Subject: McGuire Nuclear Station
Docket Numbers 50-369 and -370
Catawba Nuclear Station
Docket Numbers 50-413 and -414
Technical Specification Revision to Change Method of
Measuring Reactor Coolant System Flow Rate; Supplemental
Information

REQUEST FOR ADDITIONAL INFORMATION
REACTOR COOLANT SYSTEM (RCS) FLOW MEASUREMENT METHODOLOGY

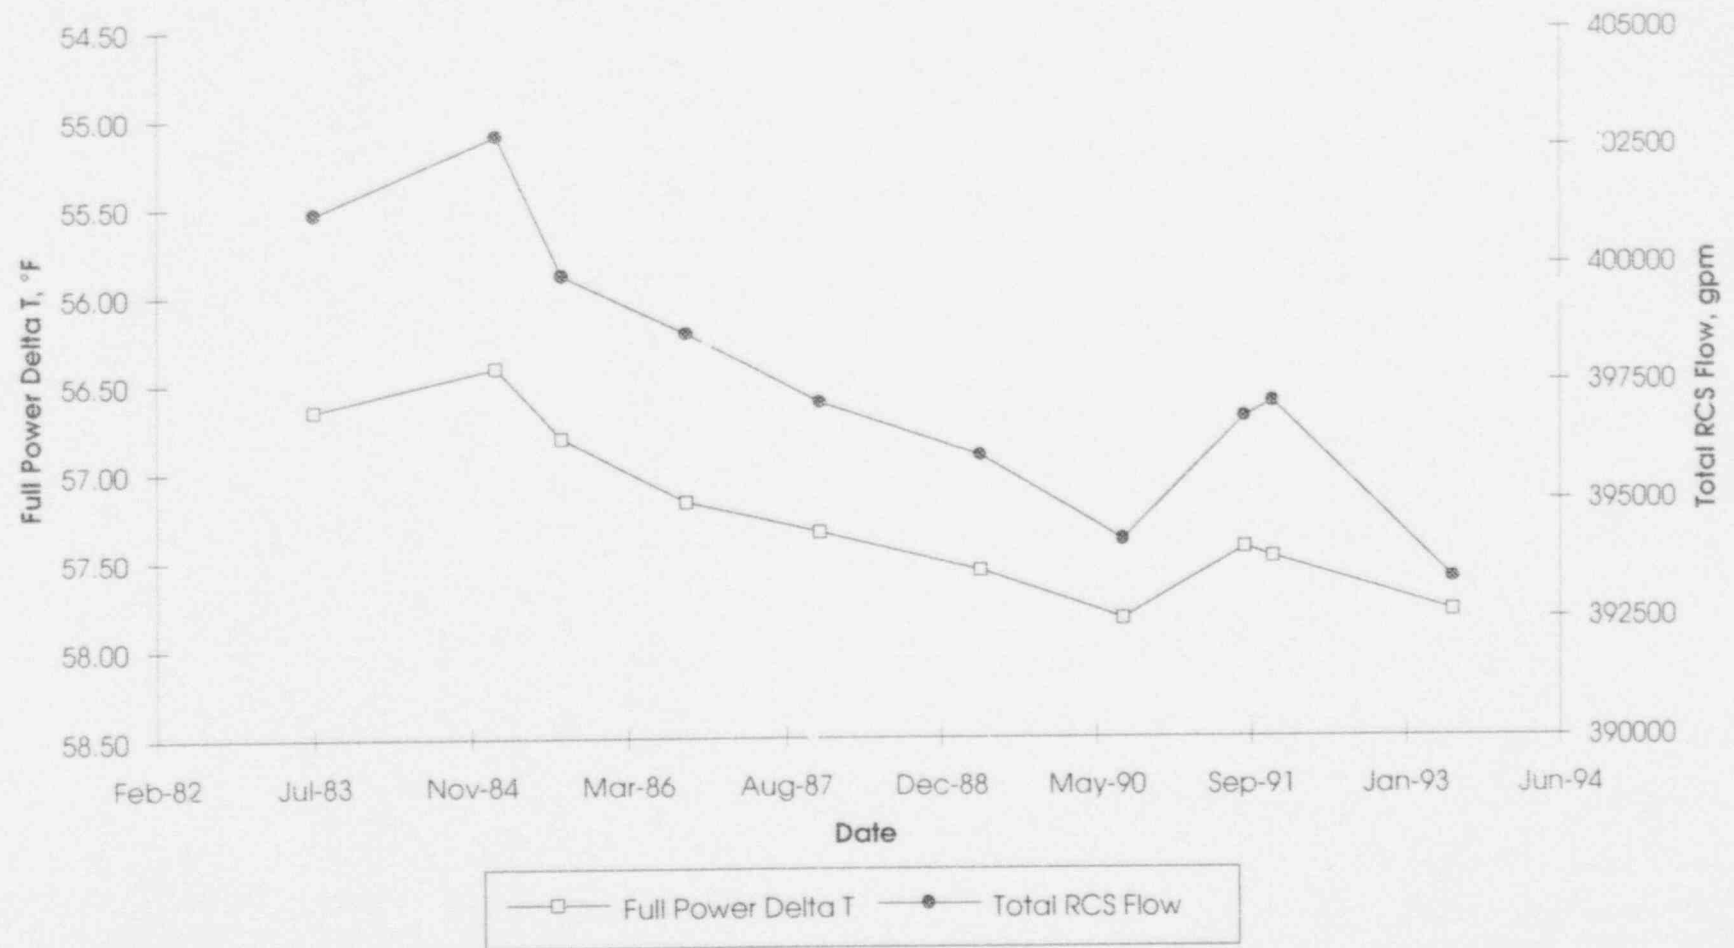
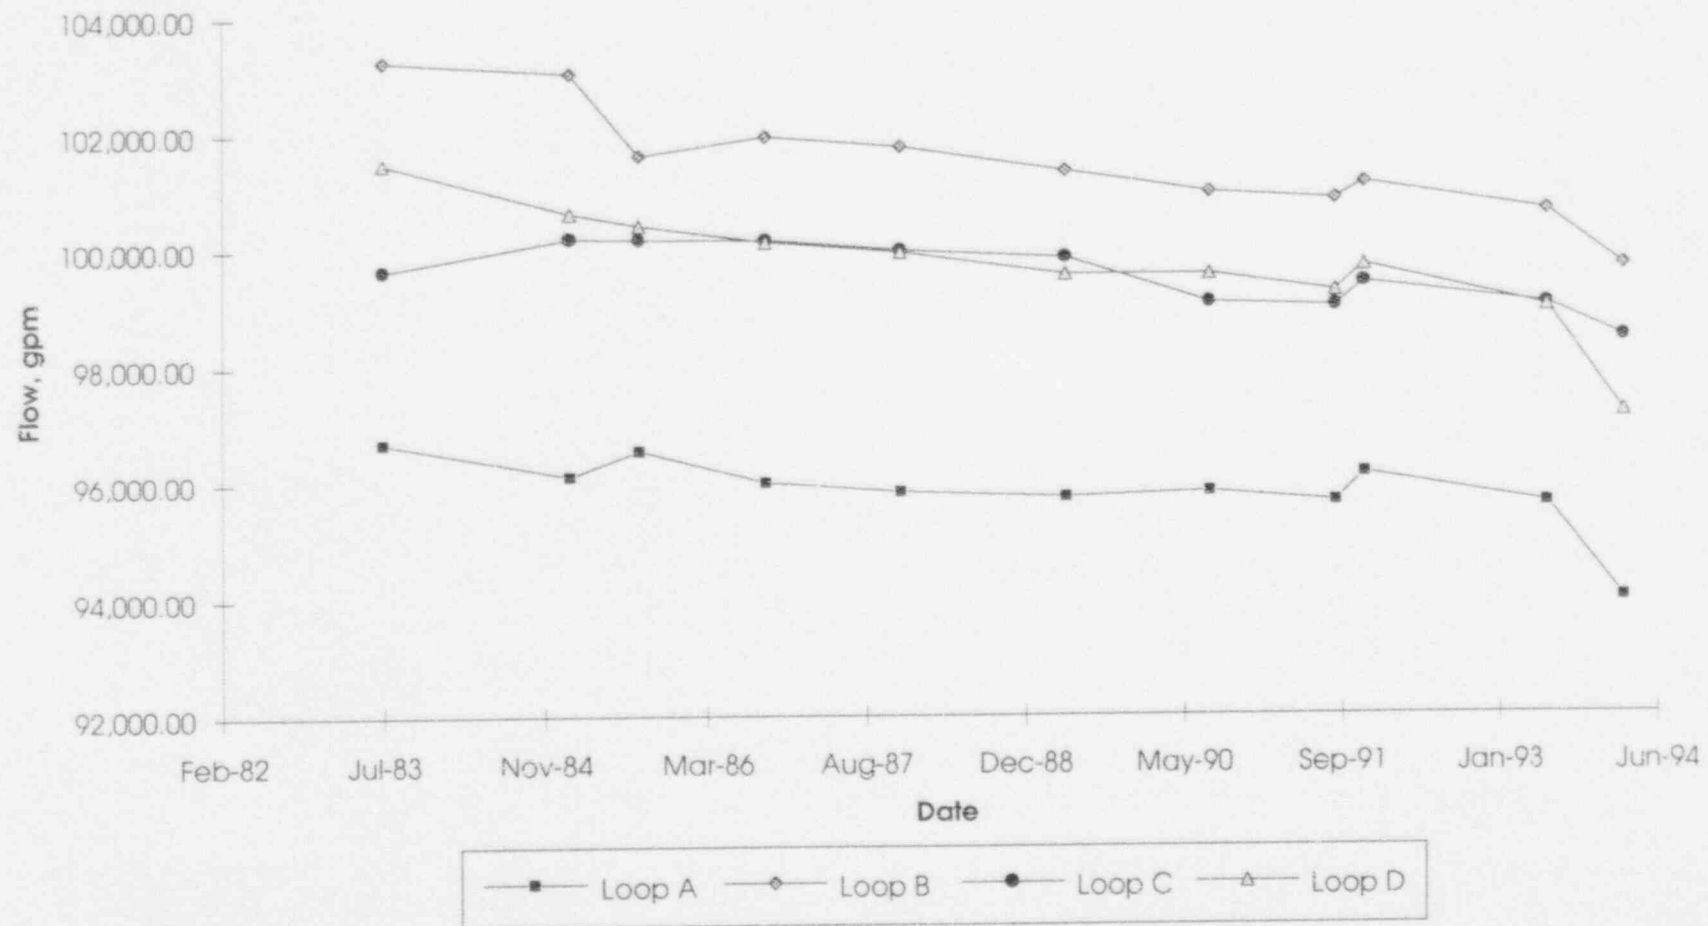
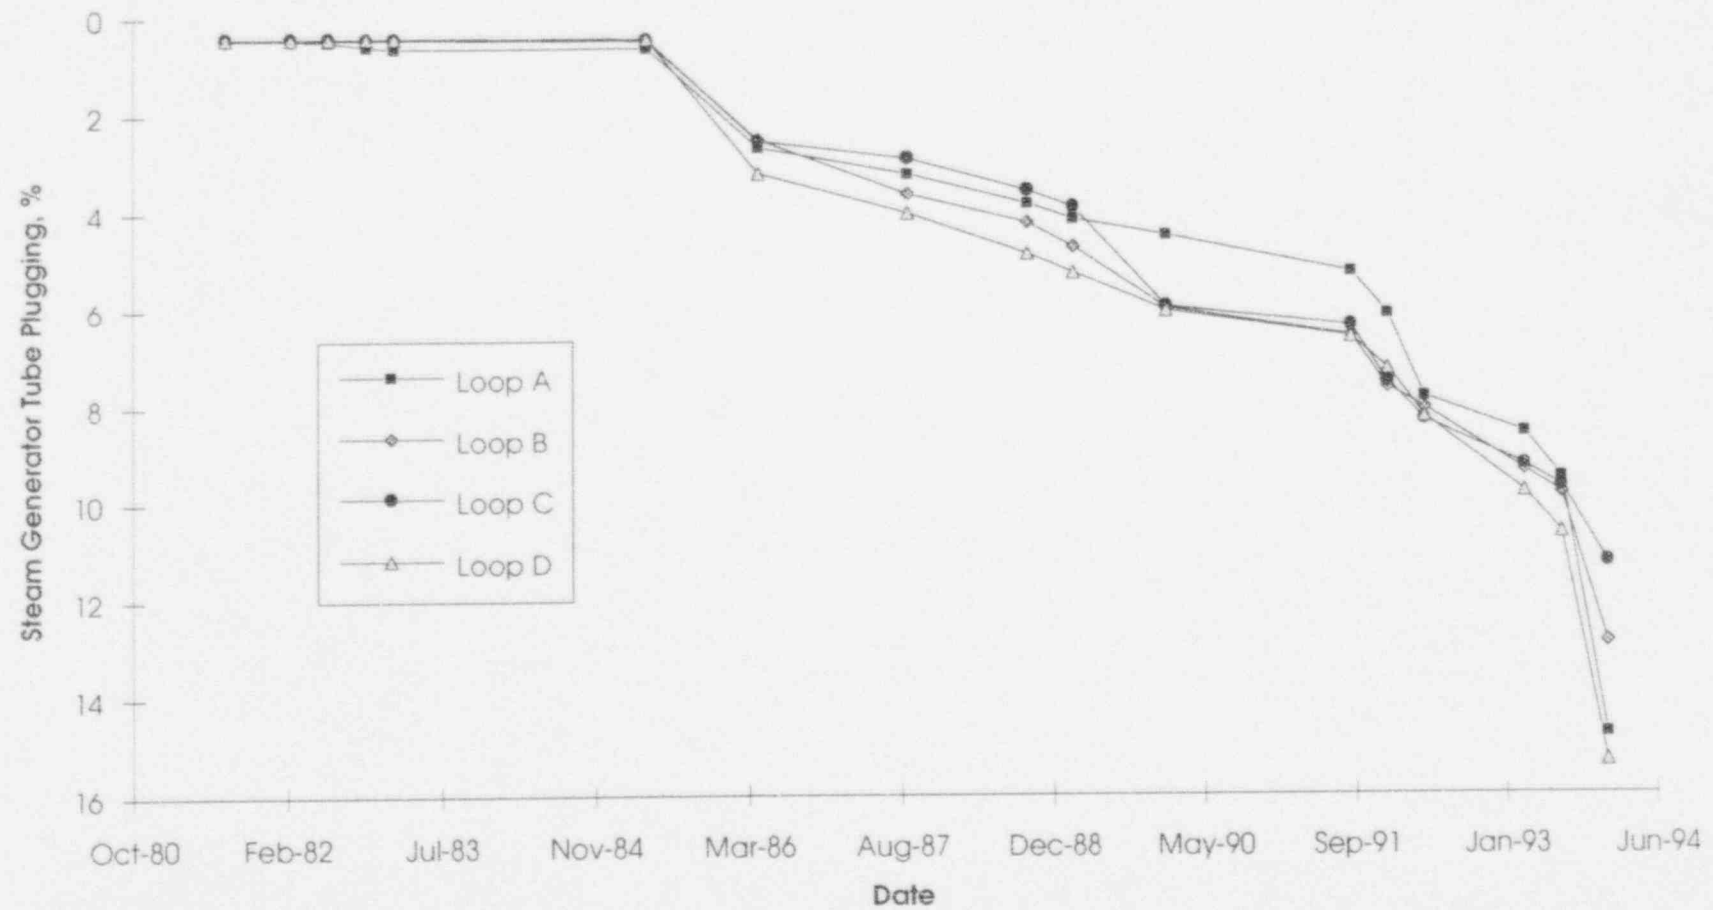
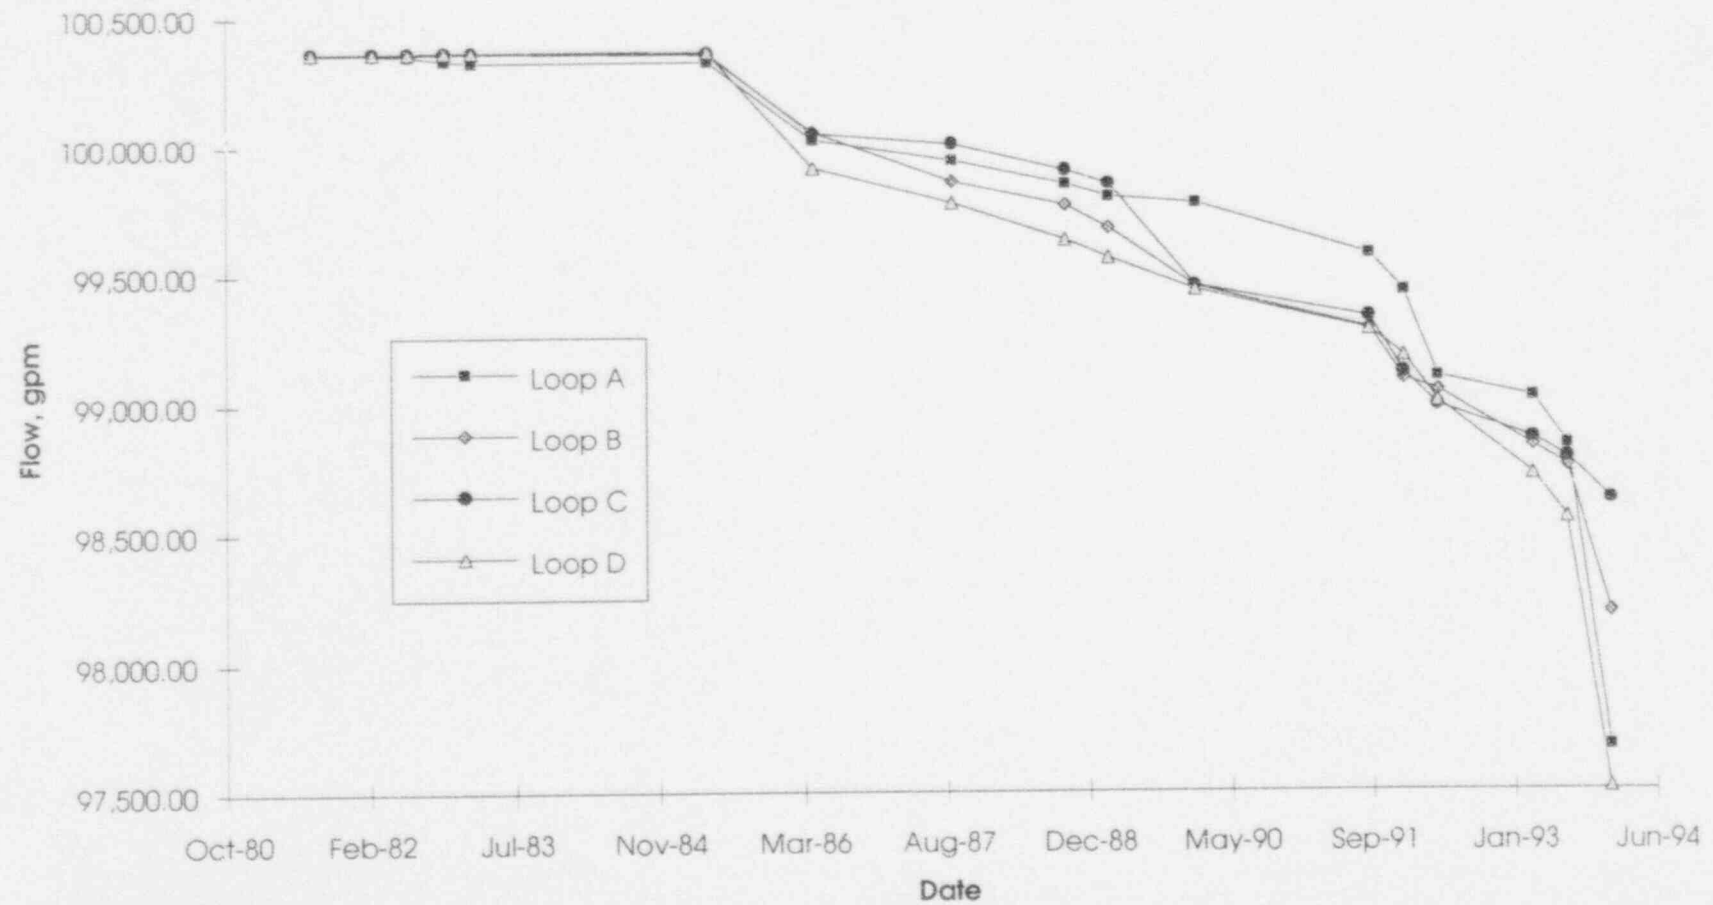
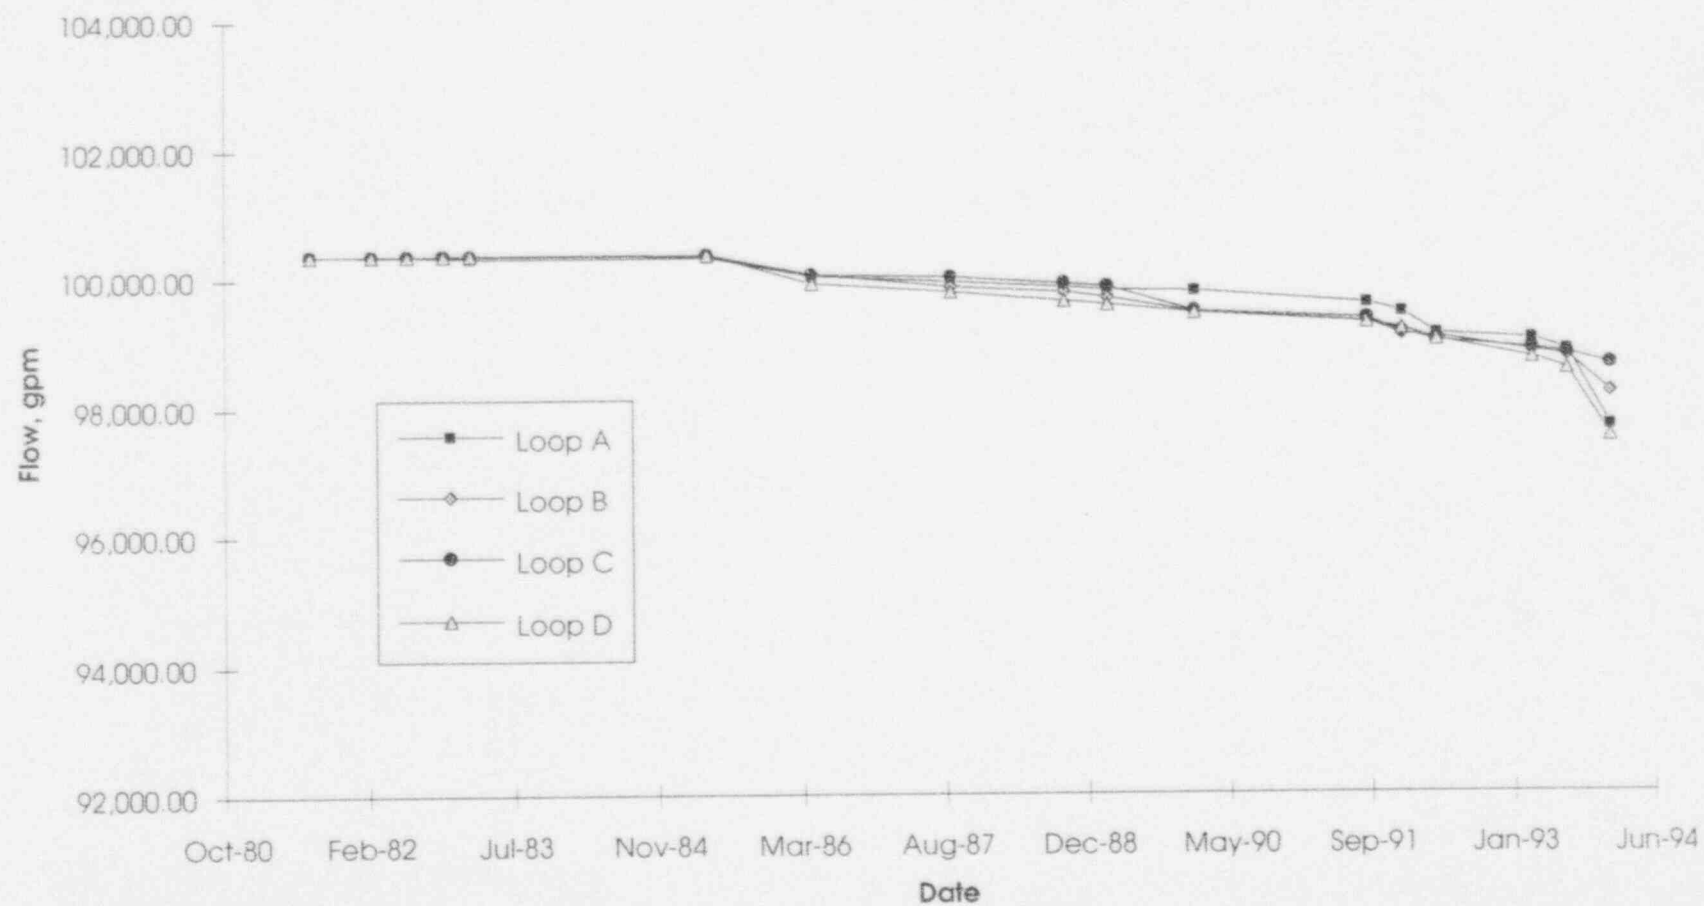
- (8) Please provide a comparison of analyses and observed RCS loop/total flow rate behavior as determined from elbow tap differential pressure indications and from calorimetric testing for both Catawba and both McGuire units. Sufficient data should be used to establish that:

McGuire Unit 1 is the one unit that thus far does not appear to be greatly affected by the hot leg streaming phenomenon. The RCS flow as measured by the calorimetric has trended very closely to the changes in full power ΔT , as can be seen in Figure 1. In addition, the changes in RCS flow as determined by the calorimetrics has generally trended with the elbow tap ΔP s with some small hot leg streaming effects. The trends in flow as determined from the indicated elbow tap ΔP s (Figure 2) and the analytical flow model (Figures 4 & 5) are in good agreement with one another (Figures 4 & 5 differ only in the Y-axis scale with the scale on Figure 5 matching the scale of Figure 2 for easy comparison). The individual loop flows given in Figure 2 indicate an unequal loop flow distribution at McGuire Unit 1 since plant startup. Generally, this is the case for the other three Westinghouse units as well, and is likely the result of differences among the as-installed loop components, e.g., piping, steam generators, and reactor coolant pumps. However, the average of the individual loop flows in Figure 2 trend very close to the individual loop flows as given in Figure 5. In addition, the individual loop flows in Figure 2 show good agreement with the changes in flow expected as the result of plant changes. The loop flows in Figure 5 are almost identical during early plant life since the analytical model loop flows were determined using the same reactor coolant pump curve and loop geometry for all loops.

All elbow tap transmitters were replaced during the September 1987 EOC 4 refueling outage. This resulted in a step increase in the elbow tap ΔP indications from those of the previous transmitters (Note: the ΔP flows in Figure 2 have a correction included for calorimetric ΔP s before September 1987). Once corrected, the elbow tap ΔP flow (Figure 2) for early plant operation agrees well with the analytical model (Figure 5) and calorimetric (Figure 1) flows.

The upflow modification was made during the September 1991 EOC 7 refueling outage along with the introduction of the first batch of B&W fuel. The upflow modification was expected to change the RCS flow distribution through the core region slightly and not effect the total flow result significantly. The B&W fuel was expected to increase flow slightly due the decreased flow resistance in the core. The increase in flow due to the new fuel was expected to be offset by steam generator tube plugging. The flow in the plant as indicated by the elbow tap ΔP s actually increased slightly after this outage. This is likely due to the new fuel having a greater effect on the flow than anticipated and partially due to the analytical flow model assumption that 1/3rd of the core would be replaced when slightly more was in fact replaced ($\approx 40\%$). The April 1993 EOC 8 refueling outage resulted in a flow decrease as indicated by the calorimetric, elbow tap ΔP flow and analytic flow model, due to any flow increase from the second batch of B&W fuel being more than offset by substantial steam generator tube plugging.
